Proposal #15: 1100-37-70, WISC 2015 124
Milwaukee – Fond du Lac
Pilgrim River Bridges
USH 41/45
Waukesha County

This is Addendum No. 1, which provides for the following:

ADDENDUM NO. 1

Addendum No. 1
ID 2720-10-70
Revised Sheet 47
February 19, 2015

TYPICAL BASIN SECTION
N.T.S.

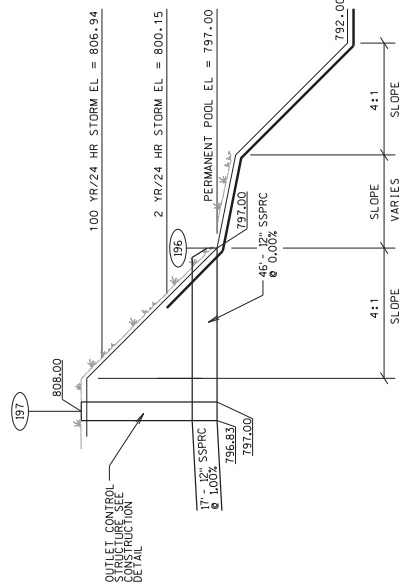
Revised Plan Sheets	
Plan Sheet	Plan Sheet Title (brief description of changes to sheet)
47	Construction Details (Corrected wording on Typical Basin Section detail)

- CONTRACTOR TO OVEREXCAVATE SAND SEAM LAYERS (IF ENCOUNTERED) AND REPLACE WITH 2 FEET COMPACTED LEAN CLAY MATERIAL. CLAY SPOILS FROM BASIN EXCAVATION MAY BE USED AS CLAY LINER MATERIAL.
- UNSATURATED CLAY IS TO BE USED FOR PERCHED DRAINS. PERCHED DRAINS MAY BE NECESSARY TO CONTROL PERCHED GROUNDWATER CONDITIONS DURING EXCAVATION OF BASIN.
